**Subject: MHI's Responses to US-APWR DCD RAI No. 571-4365**

Responses to Request for Additional Information  
No. 571-4365 Revision 0  
(Follow up to No. 362-2278 Revision 0)

**RAI NO.:** NO. 571-4365 REVISION 0  
**SRP SECTION:** 09.02.02 – REACTOR AUXILIARY COOLING WATER SYSTEM  
**APPLICATION SECTION:** 9.2.2  
**DATE OF RAI ISSUE:** 4/13/2010

Figure 2.7.3.3-1 Component Cooling Water System (Sheet 1 of 2)

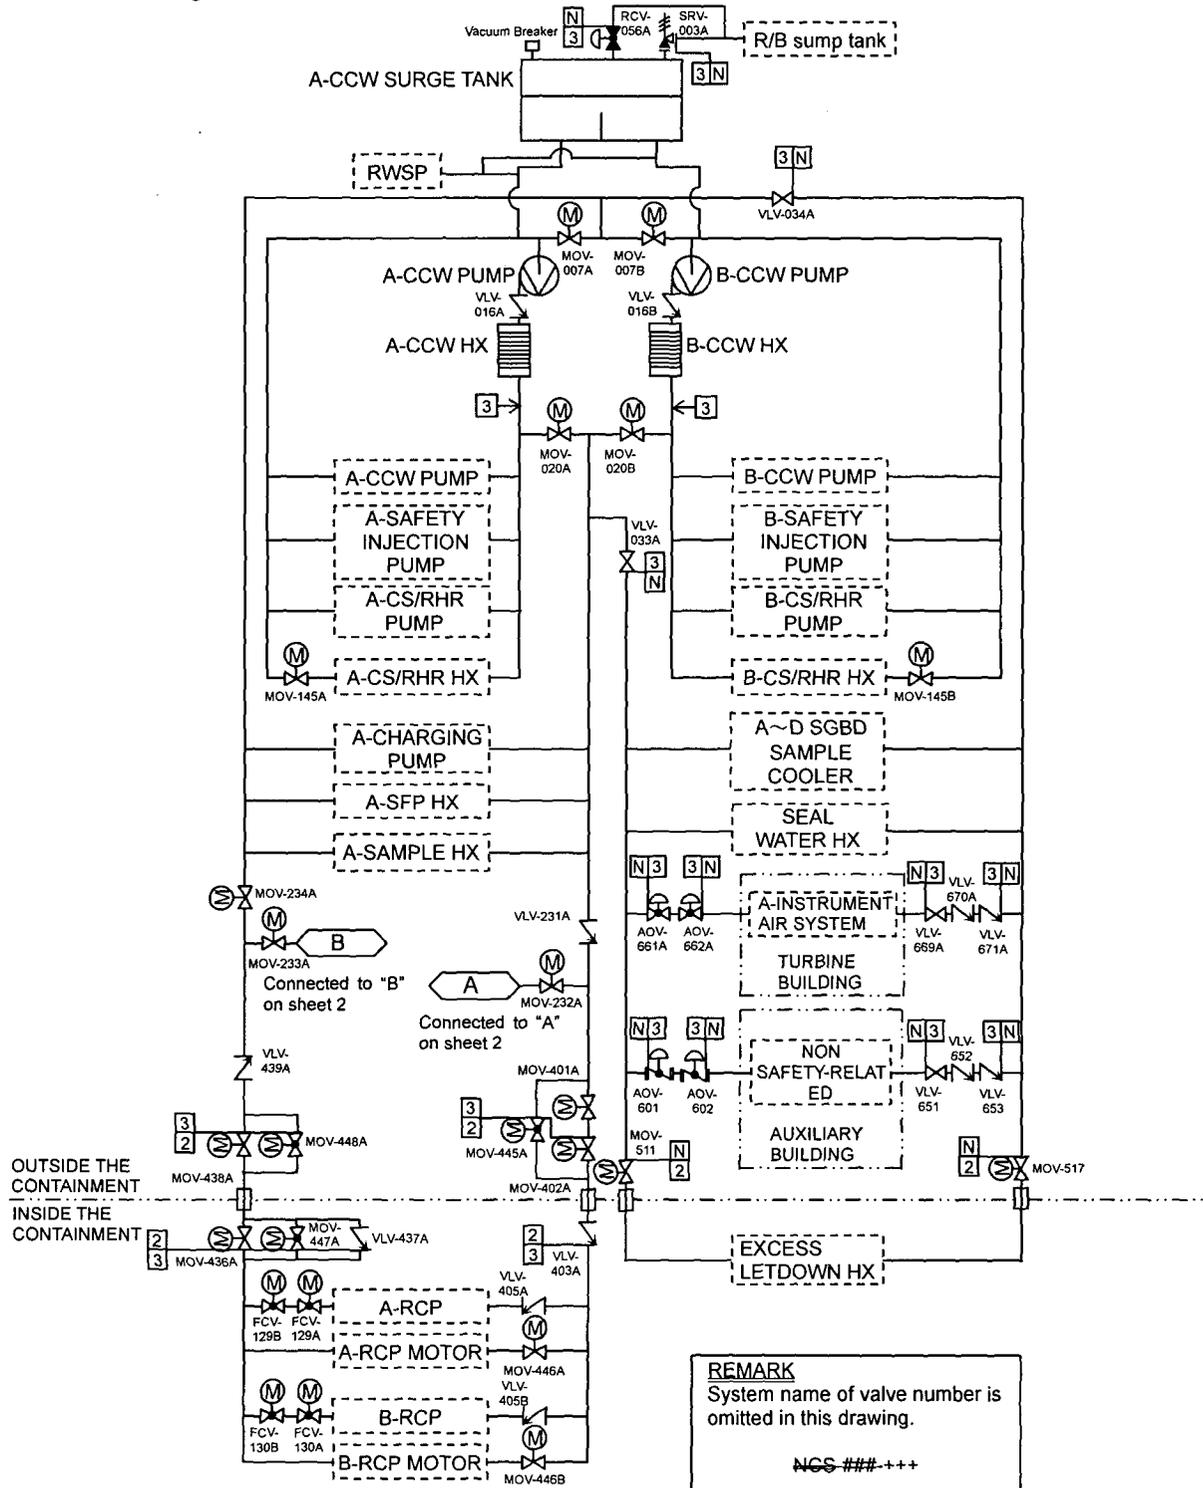
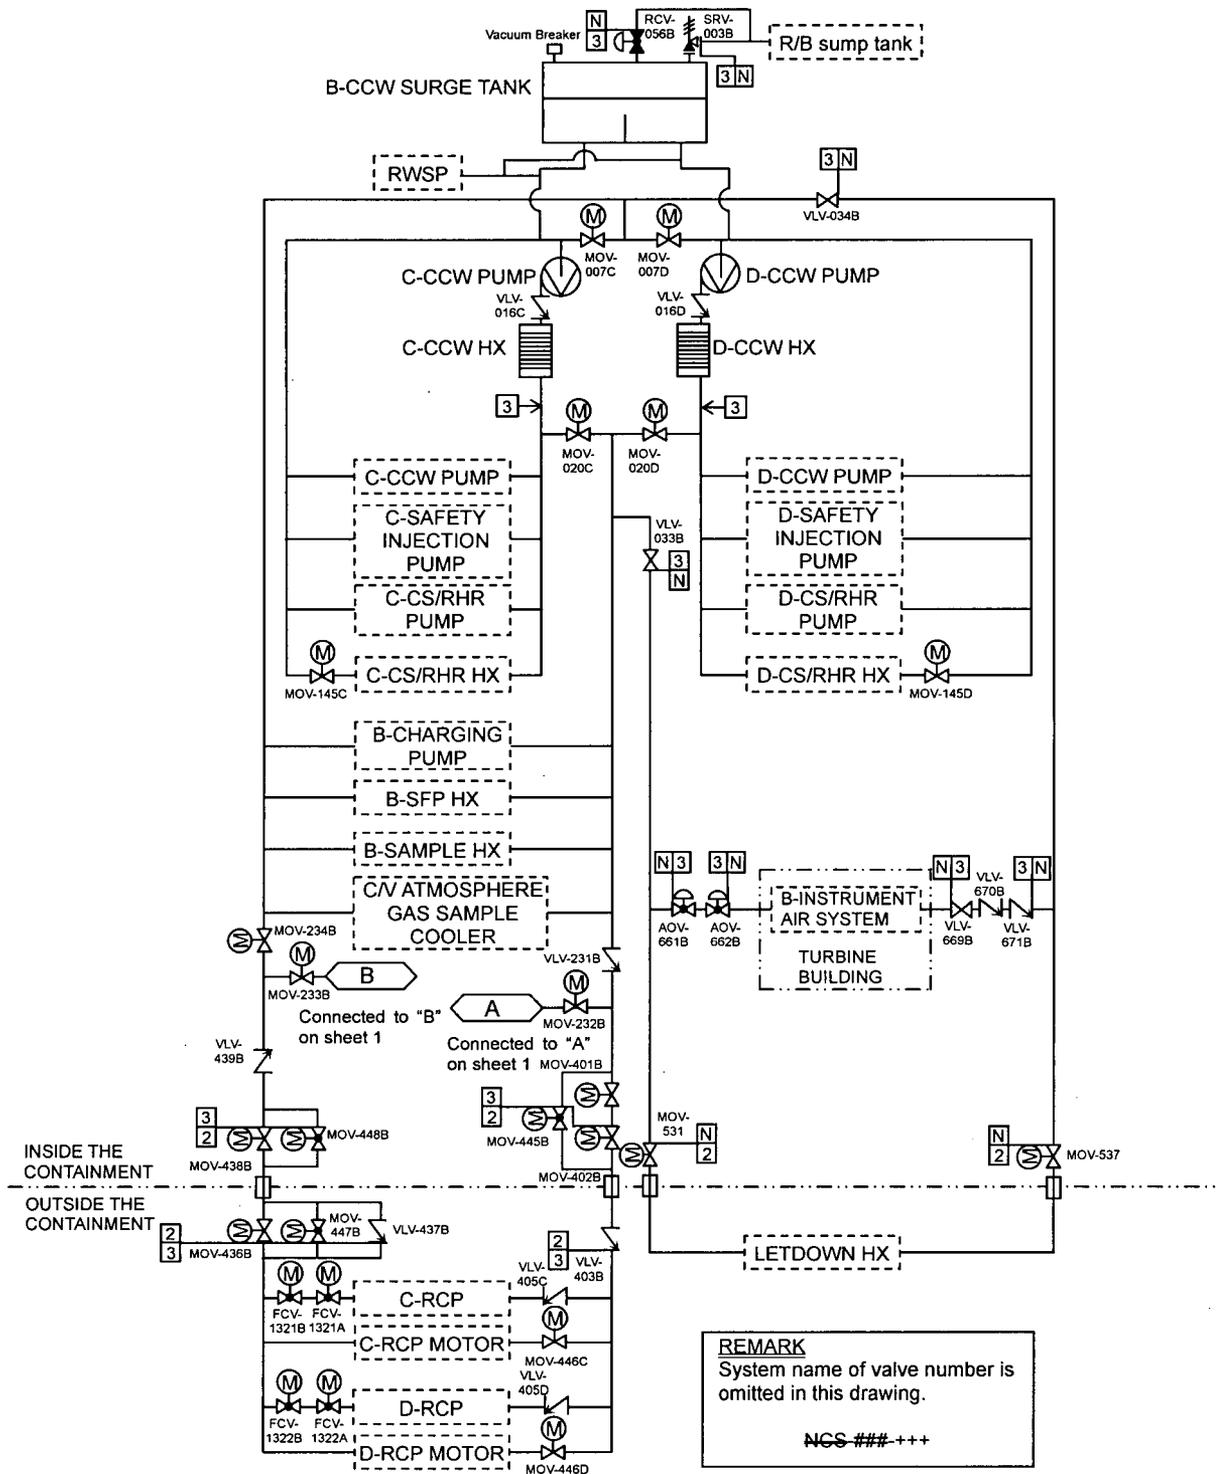
Items 8 and Item 10: The staff was unable to accept the response since it was unclear as to whether the surge tank is sized for system leakage for 7 days without makeup or if credit is taken for a seismic source for 7 days. The tank size and seismic makeup should be address in Tier 1.

Item 15: The staff was unable to accept the response since the Tier 1 figures and Tier 2 figures disagree. Specifically, the placement of the thermal barrier cross-tie header is upstream of the charging pump as shown on the Tier 2 figures and the placement of MOV-234A/B are incorrect on the Tier 1 figures. Check valves VLV-231A and VLV-231B are important design features as part of the thermal barrier cross-tie and should be shown in the Tier 1 figures.

Item 8 and 10: Please see the response to RAI 09.02.02-51 regarding the addition of makeup water sources to Tier 1 DCD Figure 2.7.3.3-1 and Question 09.02.02-57 regarding the addition of Surge Tank volume to Tier 1 DCD Table 2.7.3.3-5.

Item 15: Tier 1 DCD Figure 2.7.3.3-1 will be revised per the attached to show check valves VLV-231A and VLV-231B. The placement of the thermal barrier cross-tie header on the Tier 1 figure has not been changed. As a functional flow diagram the Tier 1 figure is not intended to show the relative position of branches in a continuous pipe line since there is no functional difference. Likewise a future change in the relative position with no functional change should not require a Tier 1 revision.

- DCD Tier 1 Figure 2.7.3.3-1 will be revised as shown below:
